**Vogtle Project**

NRC DOCKET NUMBERS 50-424 AND 50-425  
CONSTRUCTION PERMIT NUMBERS CPPR-108 AND CPPR-109  
VOGTLE ELECTRIC GENERATING PLANT - UNITS 1 AND 2  
REQUEST FOR ADDITIONAL INFORMATION: Q430.72

Attached for the review of your staff is a revision to the response to Q430.72. This revision was requested by telephone on May 8, 1985 and supercedes the response provided in the referenced letter.

FIGURE 1

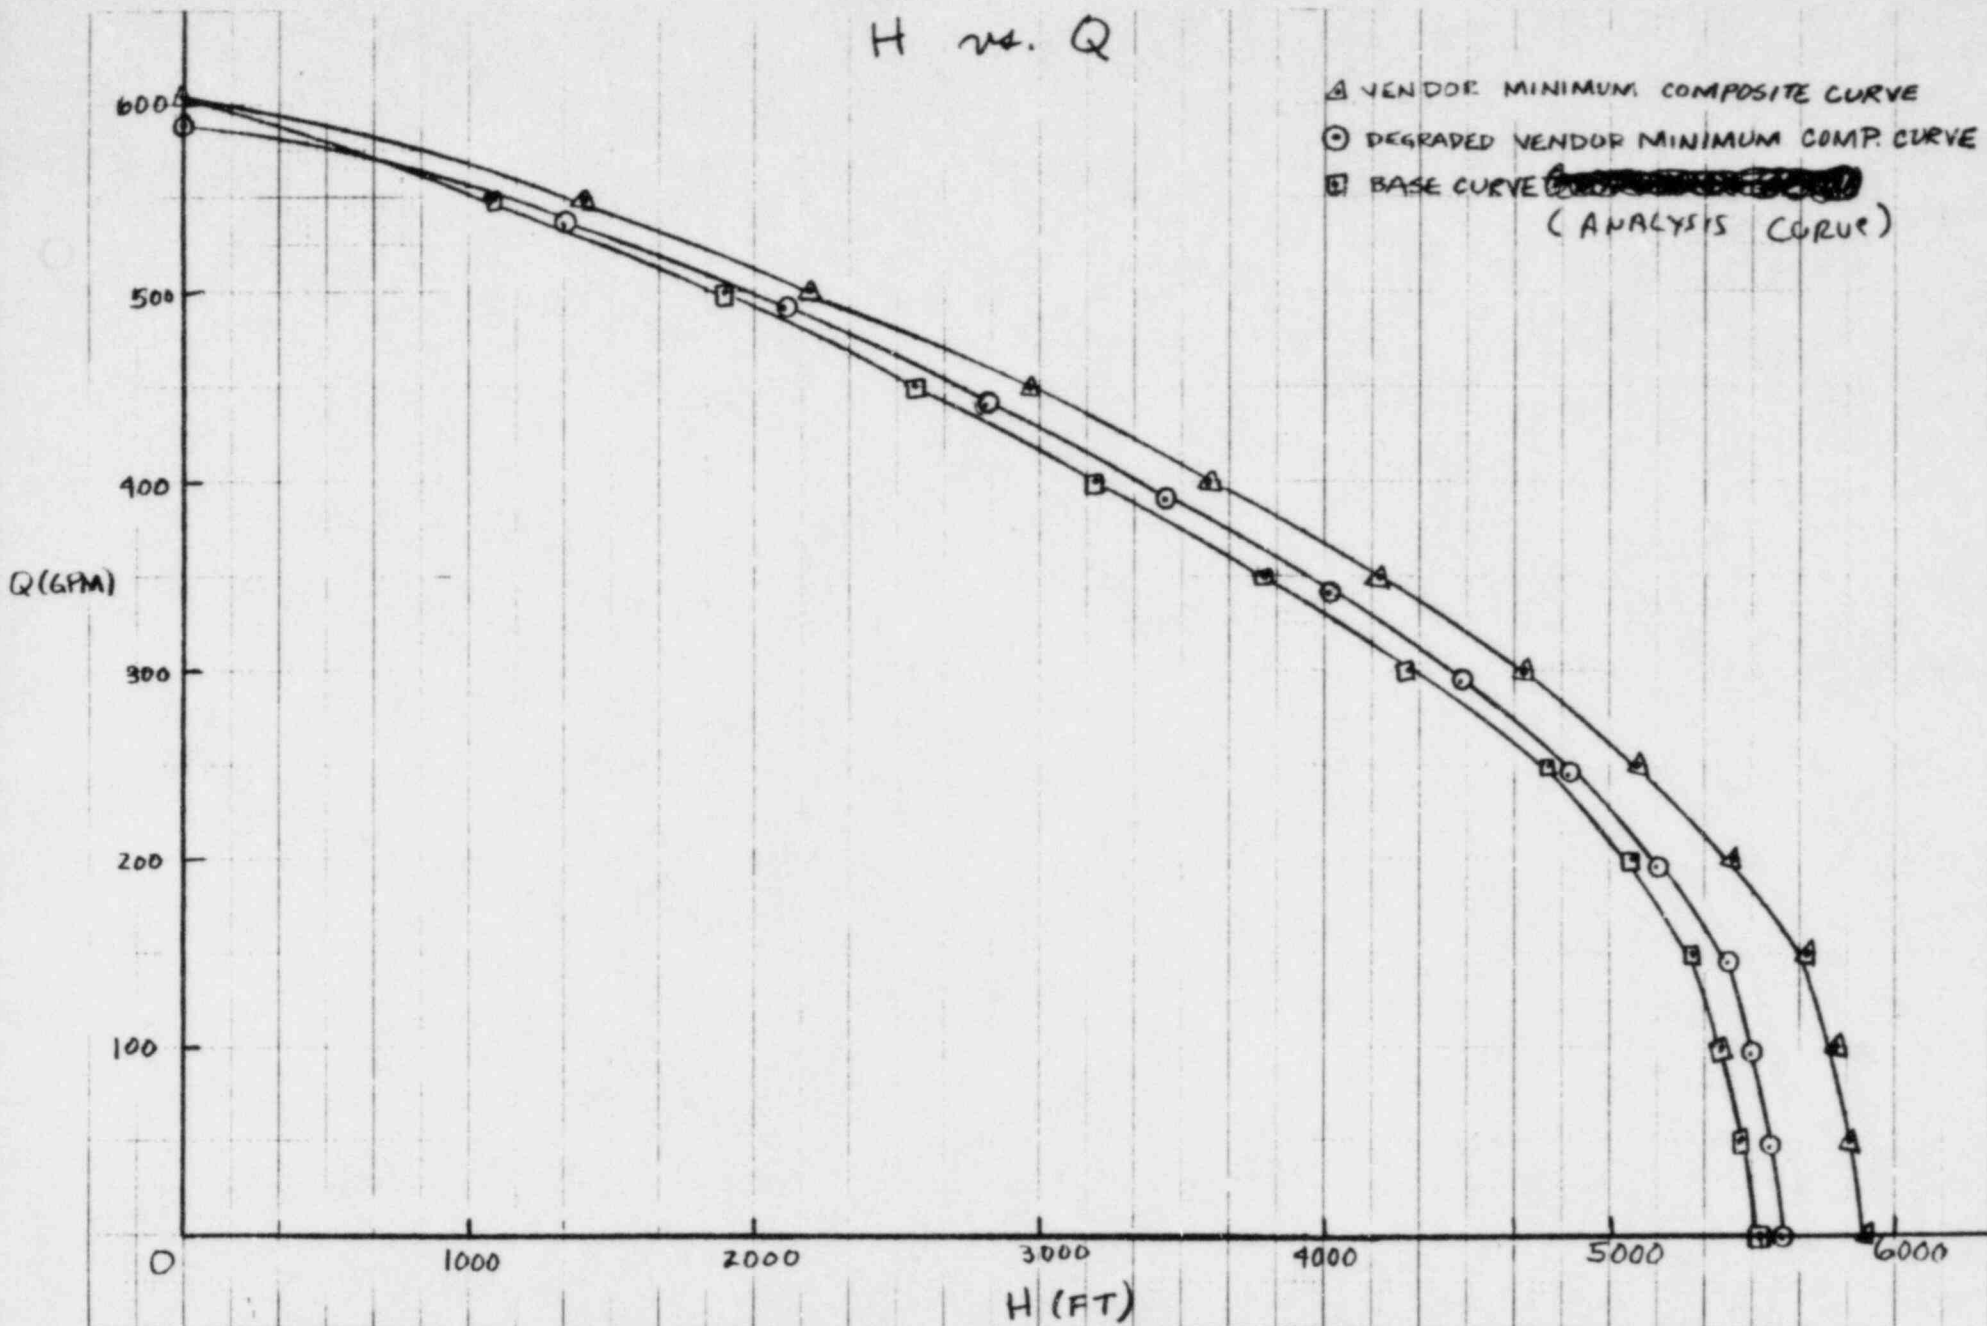
430.72(c)

Calculations have been performed to determine the effects of running the VEGP charging pumps at the degraded voltage setting (88%). The effect of running at this reduced voltage would be a temperature rise of the insulation system of the motor and the motor would run at a lower speed. The effects of running at the reduced voltage are a temperature rise <sup>of</sup> 85°C and speed of 1755 RPM (synchronous speed is 1800 RPM and operating speed is 1771 RPM).

The insulation system used in the GAE charging pump motors is thermalastic epoxy insulation designed to NEMA Class F requirements. Per Section MG1-20.40 of the NEMA Standards, the maximum temperature rise by resistance based on an ambient temperature of 40°C with 1.15 or higher service factor for Class F insulation systems is 105°C. The temperature rise of the GAE charging pump motors at 88% voltage is 85°C, which is lower than the maximum temperatures allowed by NEMA Standards for Class F insulation.

Attached are flow curves for comparison of the vendor minimum curve, accident analysis curve and the curve resulting from the degraded voltage. As can be seen, the degraded voltage curve is acceptable with respect to the analysis curve.
